Subject: Braidwood Station Unit 1
NRC Docket Number: 50-456

Response to Request for Additional Information Pertaining to Operating Interval
Between Eddy Current Inspections for Circumferential Indications in the
Braidwood Unit 1 Steam Generators

ATTACHMENT A
REQUEST FOR ADDITIONAL INFORMATION
RELATED TO THE BRAIDWOOD, UNIT 1 CYCLE LENGTH ASSESSMENT
BASED ON STEAM GENERATOR (SG) TUBE
CIRCUMFERENTIAL INDICATION GROWTH RATES
DOCKET NUMBER 50-456

Figure 1a. Industry Tube Pull/Insitu Indication Average Volts vs. Maximum Volts

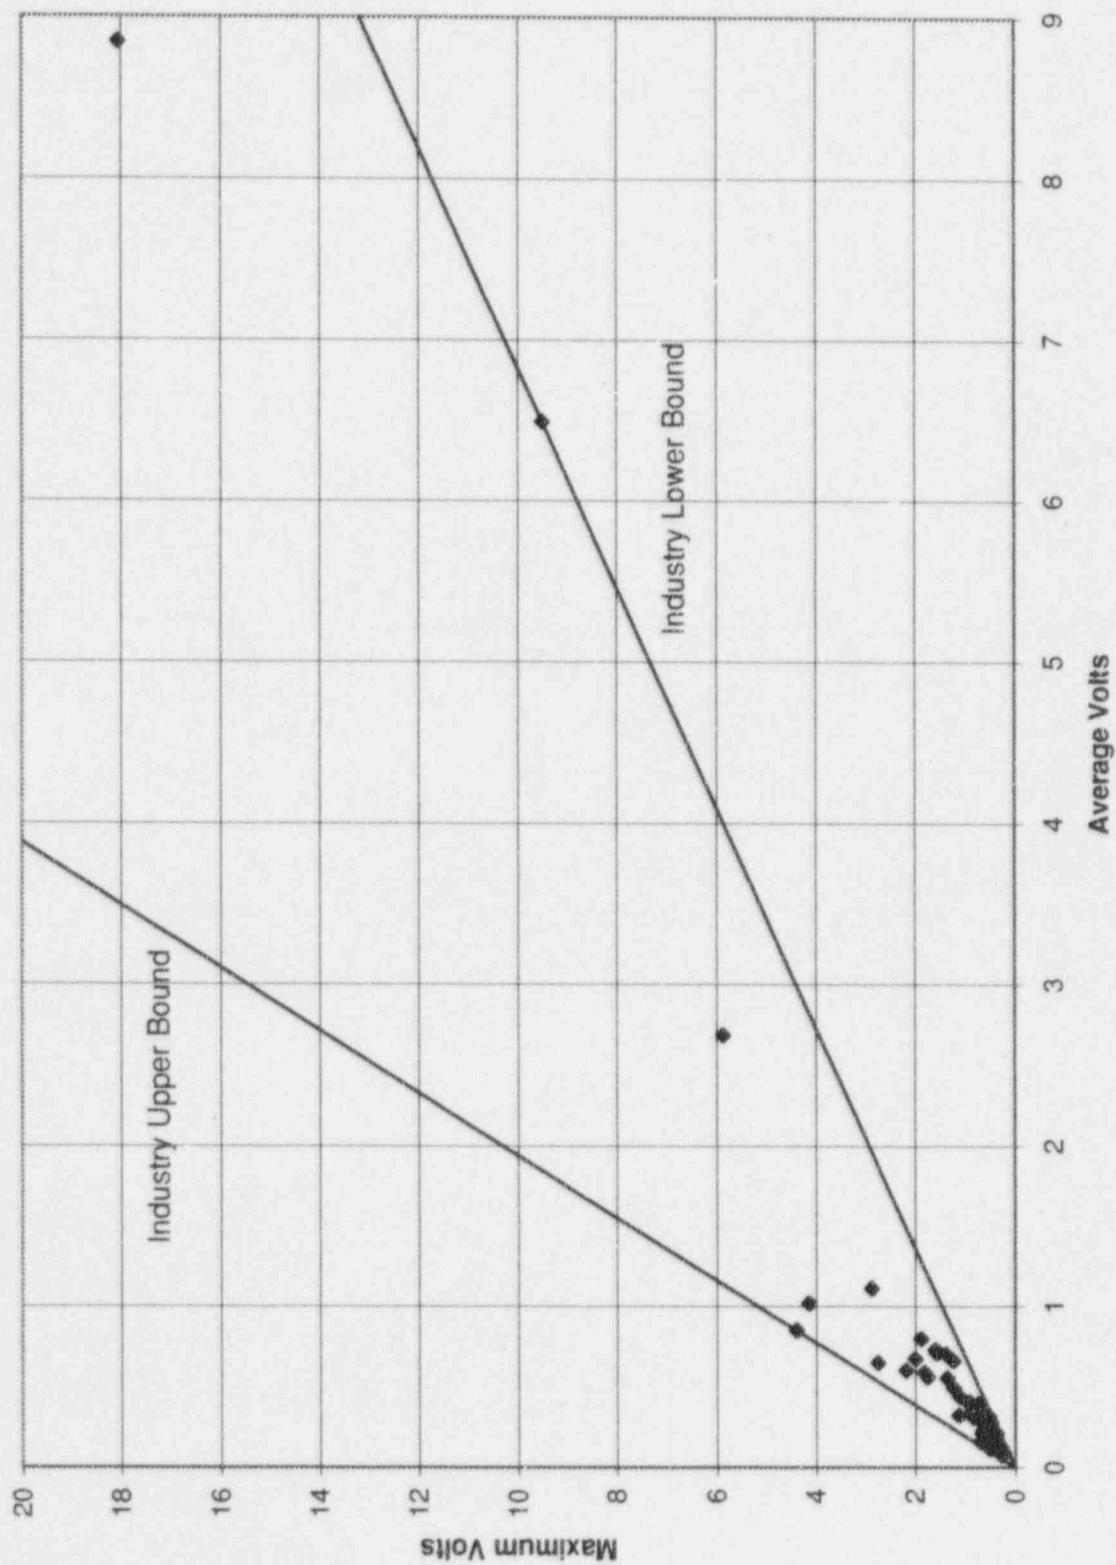
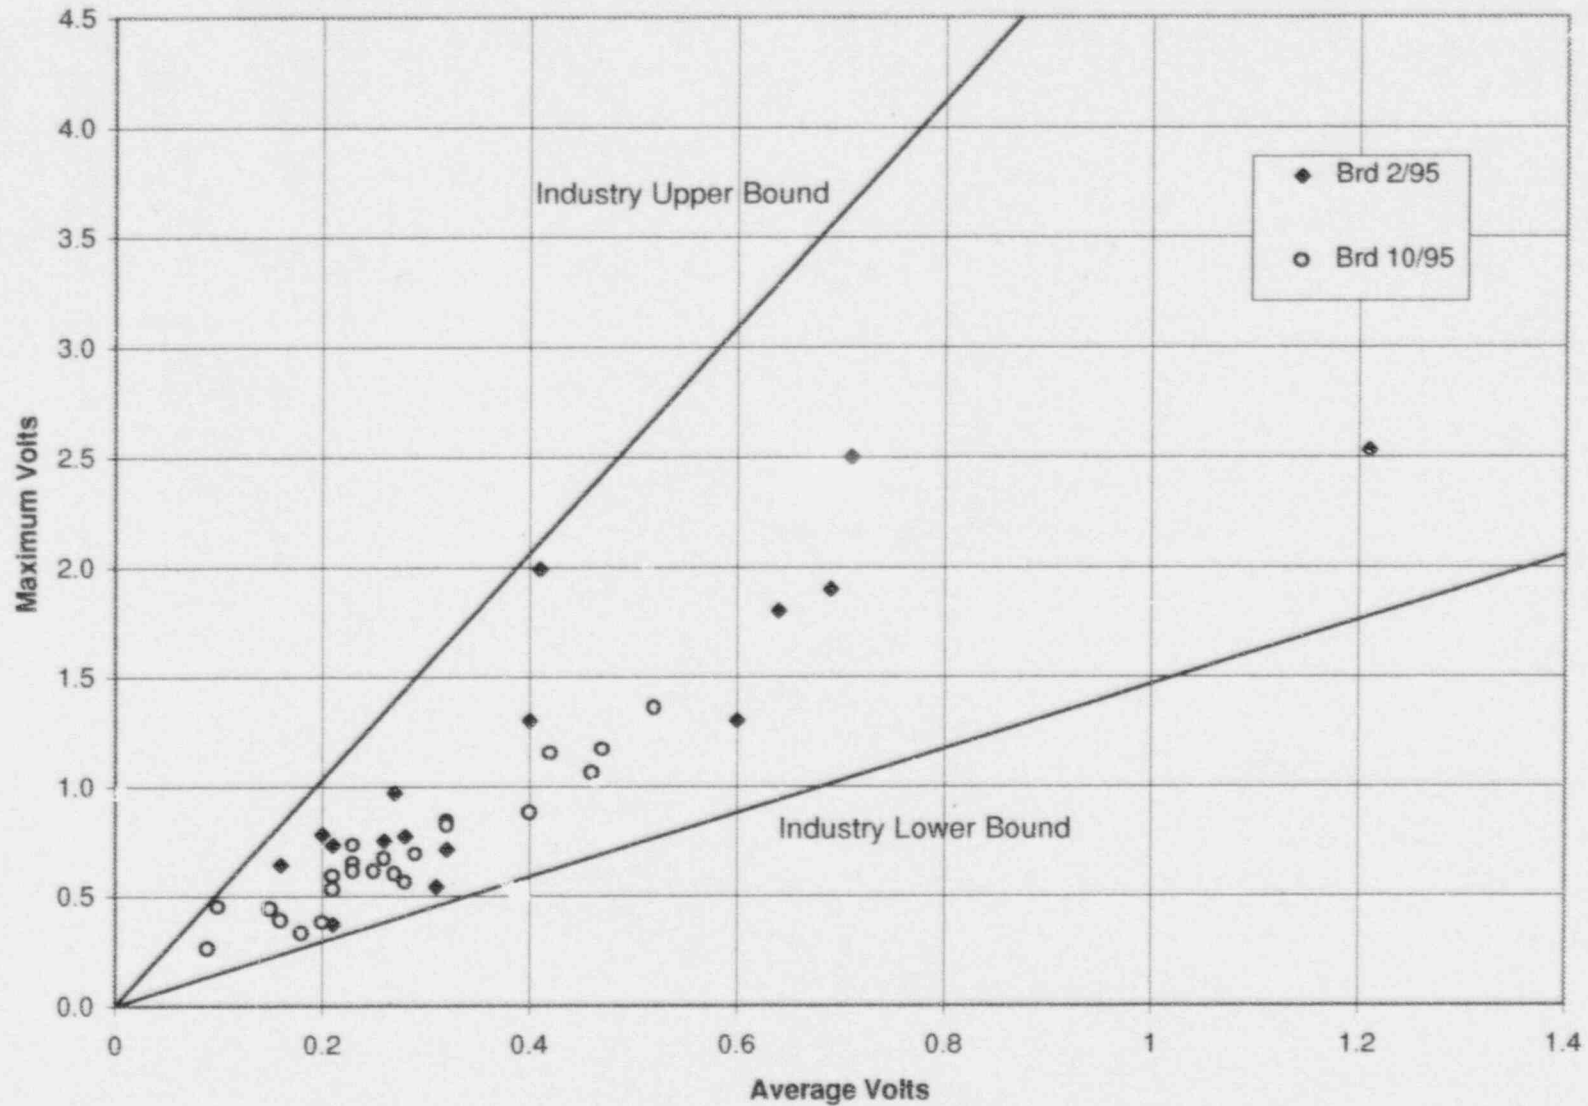
1. In the license's submittal dated August 2, 1996, a morphology assessment was provided which attempts to demonstrate the similarity between circumferential crack indications in Braidwood, Unit 1 to Byron, Unit 1 based on the relationship between the maximum and the average eddy current (EC) voltages. However, the licensee did not provide a sufficient basis for assuming an eddy current voltage assessment is indicative of degradation morphology. Accordingly, provide data supporting the assumption that circumferential flaws (either real and/or simulated) with morphologies different from that found at Byron Unit 1 demonstrate a different and clearly distinct relationship between the average and the maximum EC voltage such that differing morphologies could be distinguished.

Additional NDE confirmation that the Braidwood Unit 1 circumferential indications are within the Byron Unit 1 and industry experience base is provided by the plots of EC maximum versus average voltage in Figures 1a and 1b. Figure 1a shows the industry data base for pulled tubes (56 data points) and the bounds that encompass the data. These data include data from Byron Unit 1. These data also include a range of degradation levels including a tube where the percent degraded area (PDA) was approximately 94% (also see response to Question 9). Figure 1b shows a comparison of the bounds for the industry experience with the indications detected during the February 1995 and October 1995 inspections at Braidwood 1. A comparison of the industry experience base, as represented by the bounding lines, with the Braidwood indications provides additional confirmation that the morphology at Braidwood Unit 1 is within the industry experience base. Three conclusions are reached based on Figures 1a and 1b.

- 1) Two EC parameter bounds can be defined that encompass all roll transition circumferential ODSCC degradation observed in the industry.
- 2) All Braidwood Unit 1 indications are within these bounds.
- 3) The trend in the Braidwood Unit 1 indication distribution is toward smaller indications.

Braidwood Unit 1 Maximum Voltage Growth 2/95 to 10/95
Figure 2a

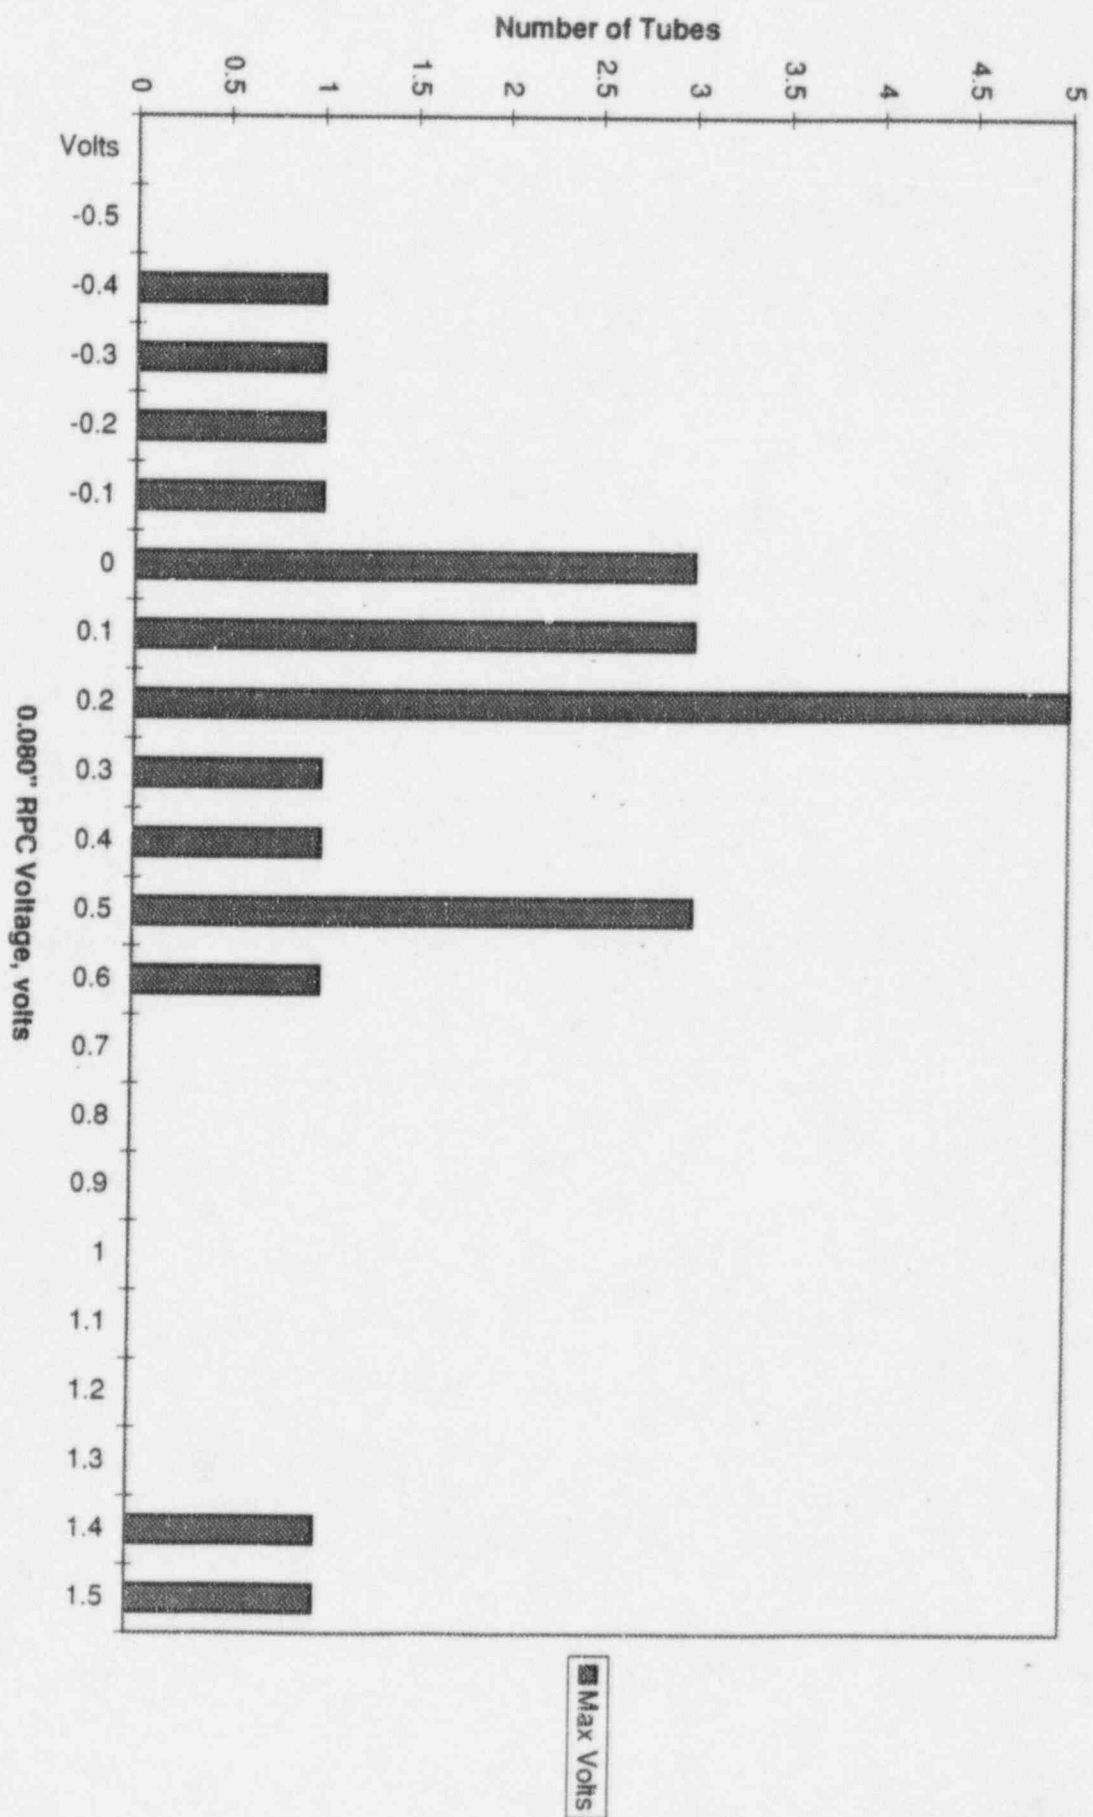
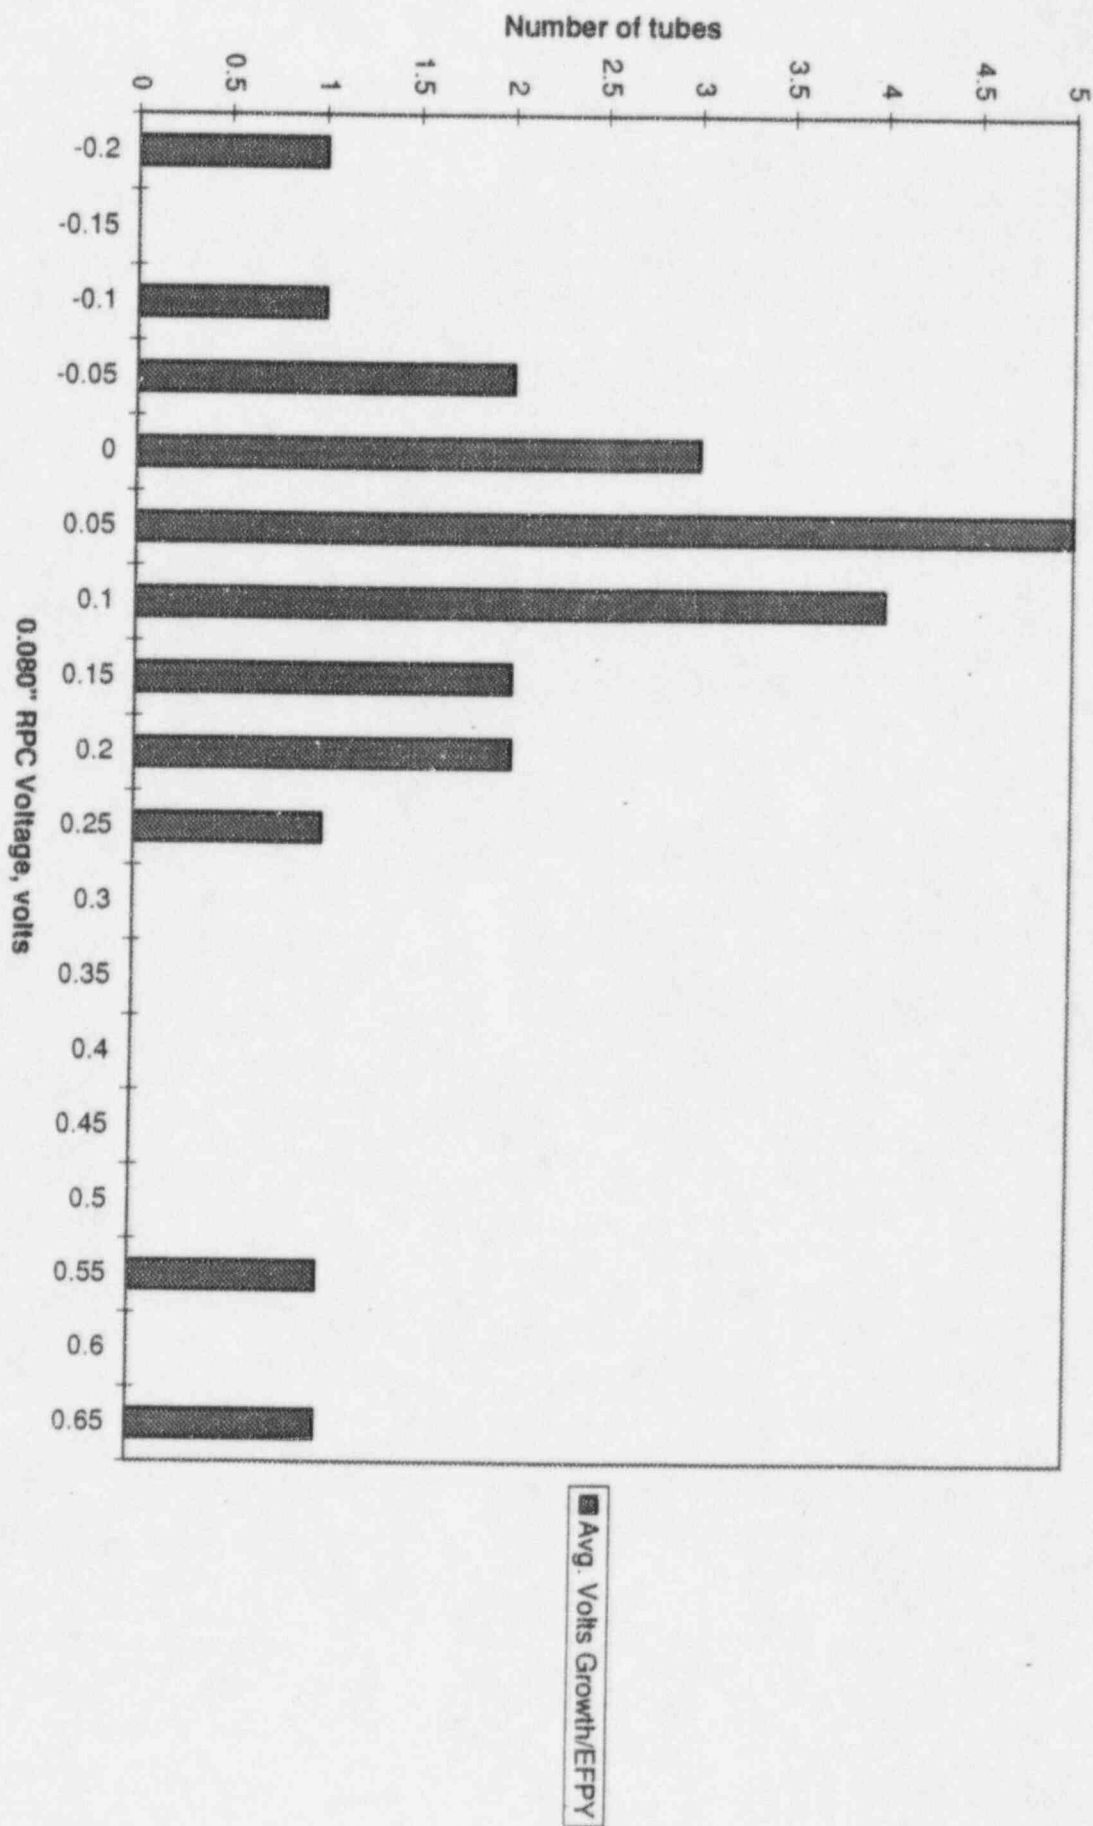
2. **In Section 4.3 of the licensee's submittal dated August 2, 1996, it is stated that Braidwood Unit 1 growth rates had not been determined at the time of the submittal due to difficulty in converting the EC test data. State when this work will be completed and submitted to the NRC. If this conversion has been completed, submit the results of the assessment.**

Twenty three indications were detected and repaired in the October 1995 inspection. All 23 were present in the look-back to the February 1995 inspection. The growth rate data is calculated by subtracting the February 1995 voltage reading from the October 1995 voltage reading. The difference is then divided by the operating period (202.74 days) and multiplied by 365 to provide the growth rate per year. The growth rate data is then put at the top of 0.1 volts and 0.05 volts bins (e.g. 0.44 volts would be placed in the 0.5 maximum voltage bin and 0.45 average voltage bin), for maximum and average voltage growth, respectively. The growth rate results are shown in Figures 2a and 2b for maximum and average voltage, respectively.
